S.S. "ARANDORA STAR"

ARRANGEMENT OF OIL FUEL FILLING & SUCTION PIPES
& AIR & OVERFLOW PIPES FOR NEW DEEP TANKS.

DRG. NO. 9680 E.

PUMPING PLAN

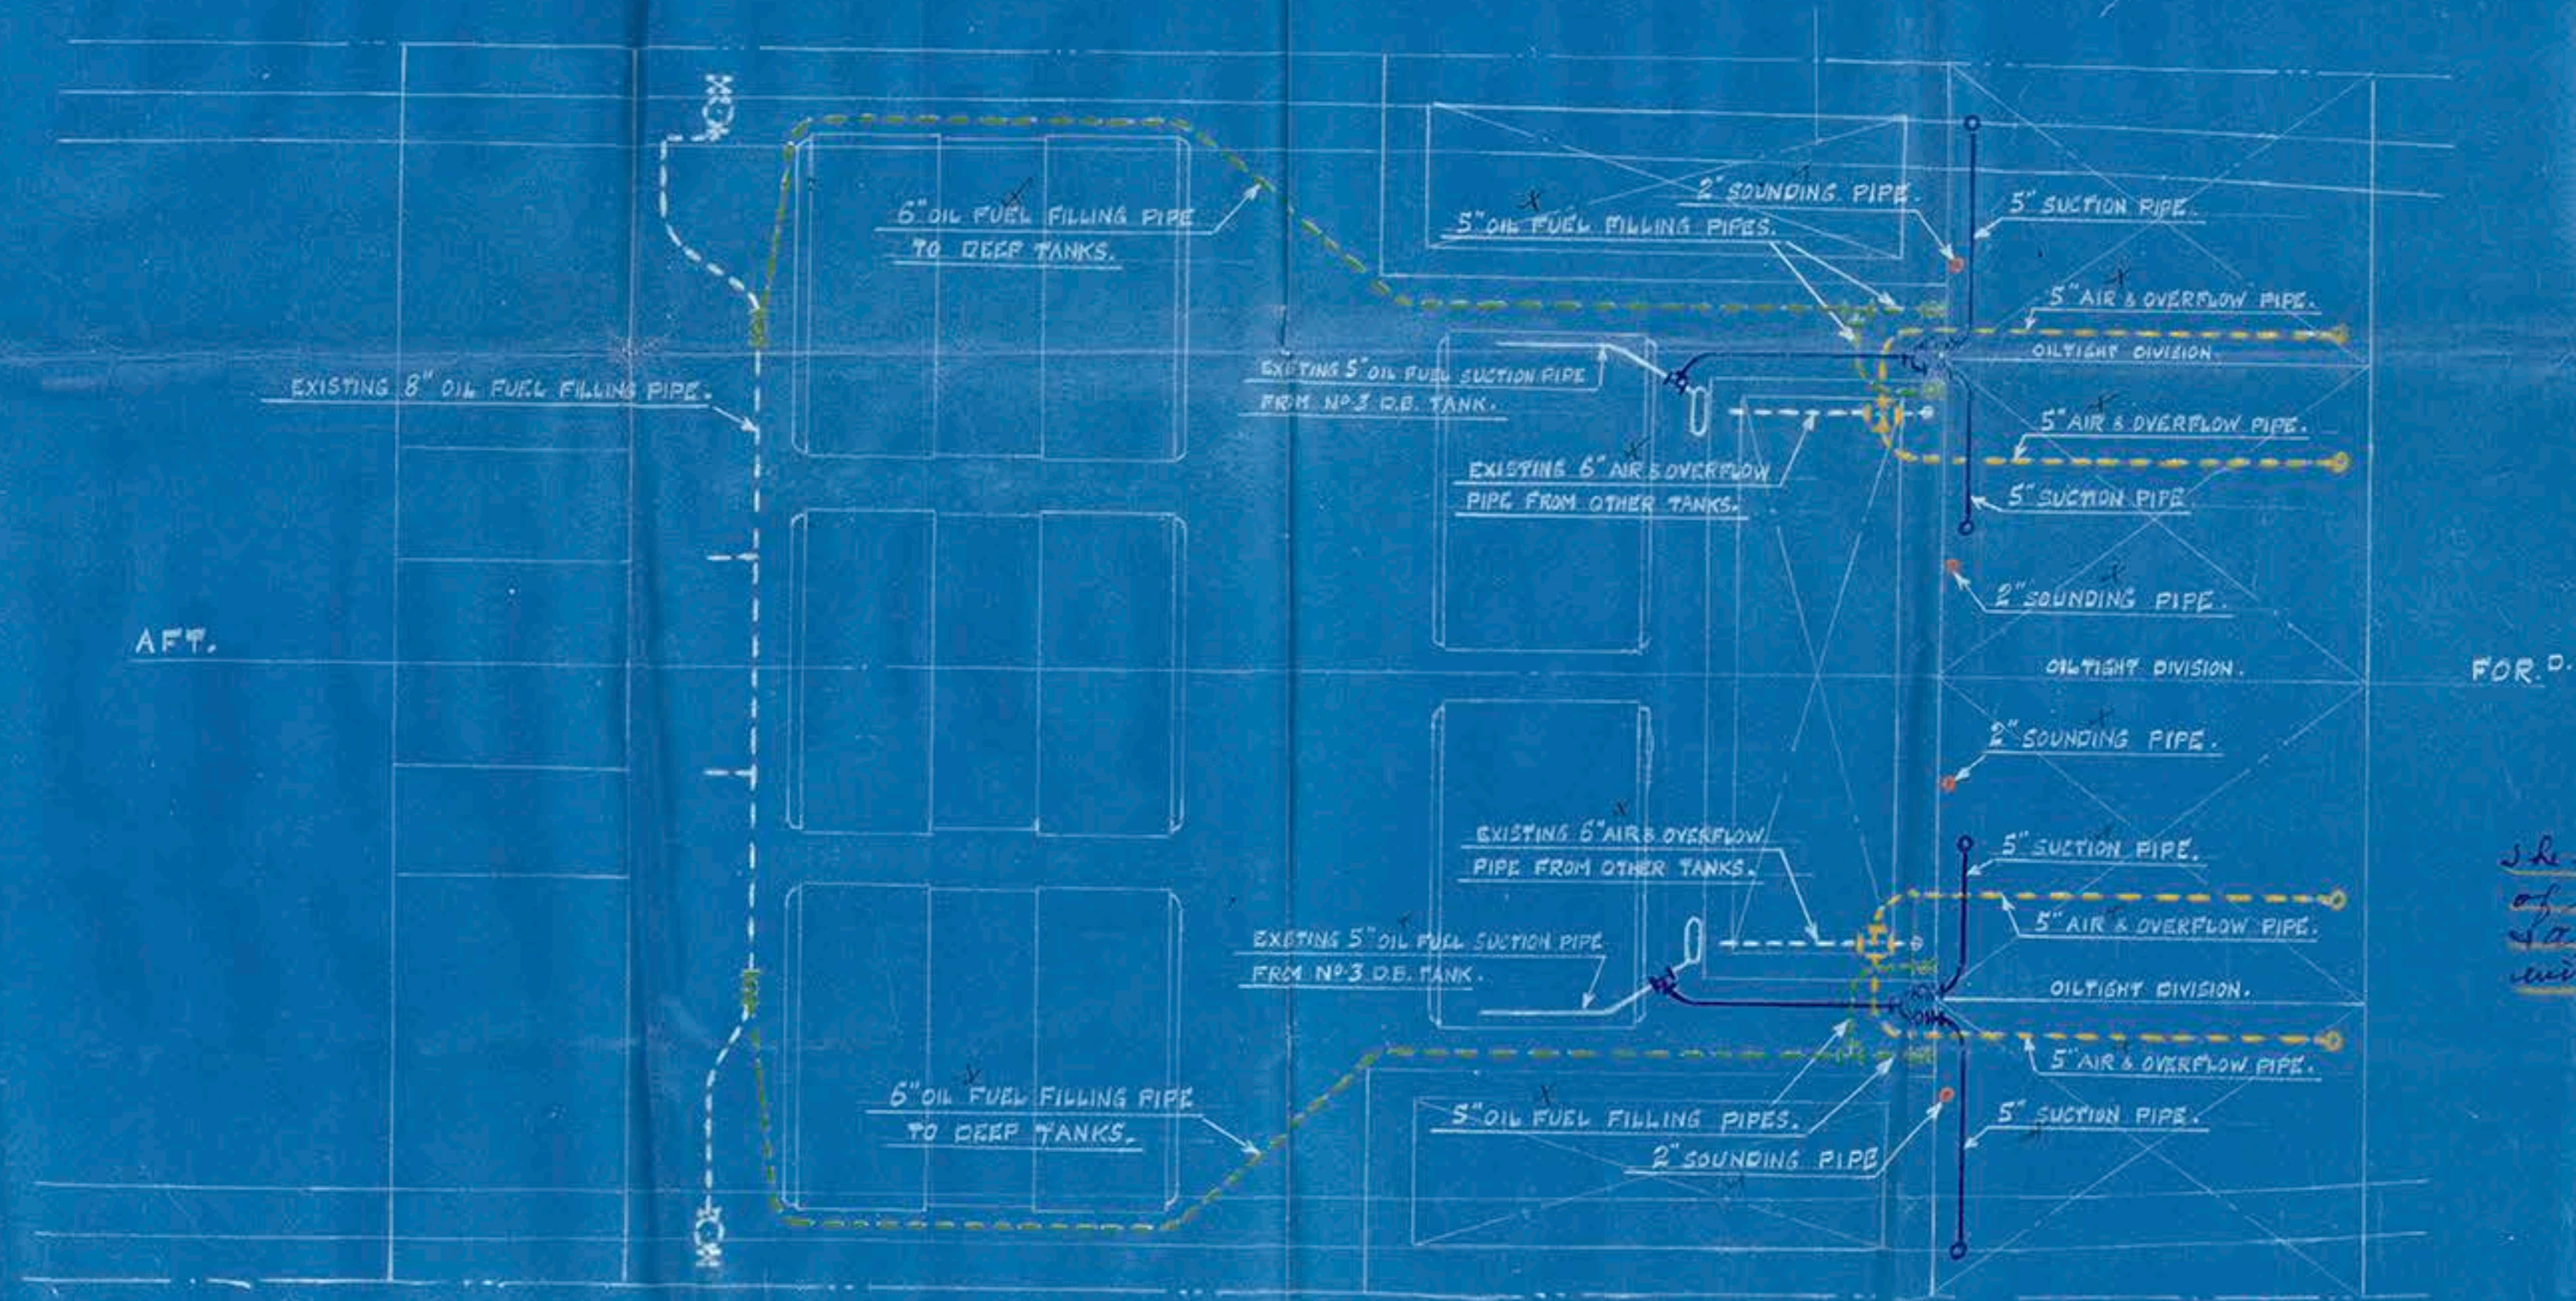
The requirements of Section 3, Sub 4, of the Rules for Refrigerating Machinery, to be complied with.

The requirements of Section 20 B, Sub 4, of the Rules (1934-5), to be complied with.

Amended plan approved 4/11/35.
Amendments:
Sounding pipes as shown with steam cut connections fitted.

The bulkhead of the oil fuel tank to be about 3/16" and the remaining requirements of Section 40 of the Rules (1934-5) to be complied with as far as they are applicable.

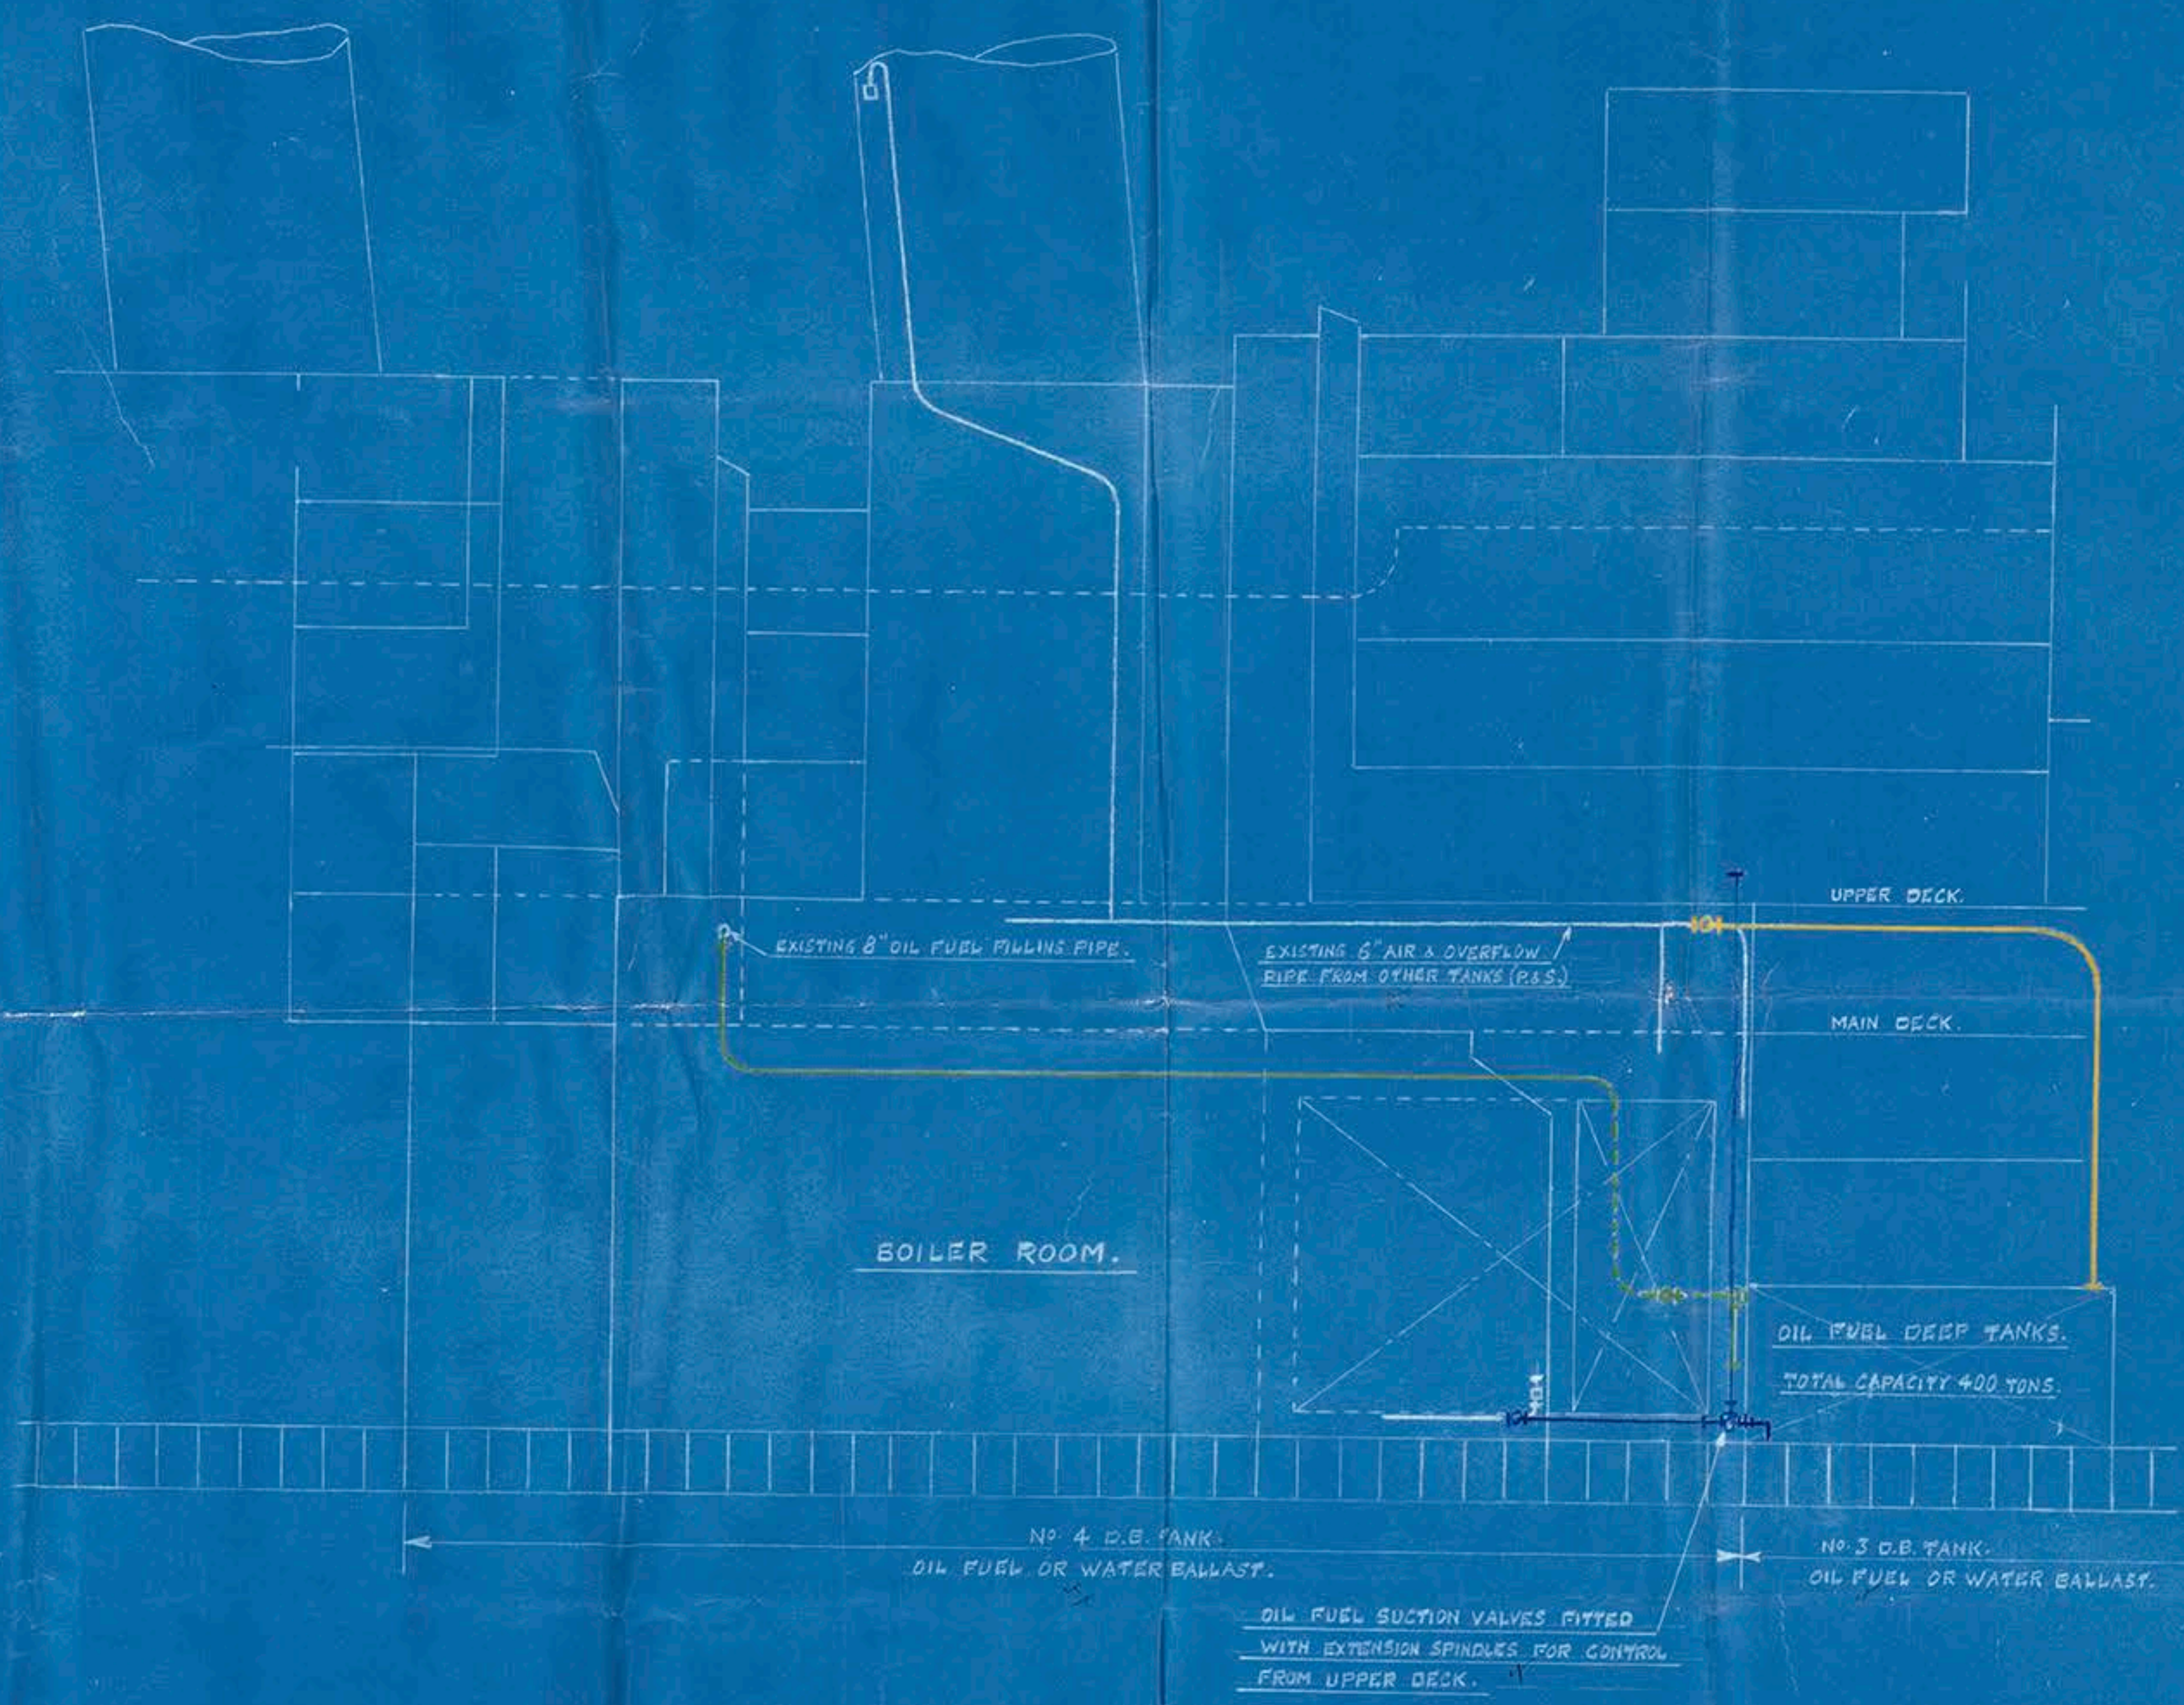
Amendments not shown on
this plan:—

Sounding pipes disapproved
with

steaming out connections
fitted
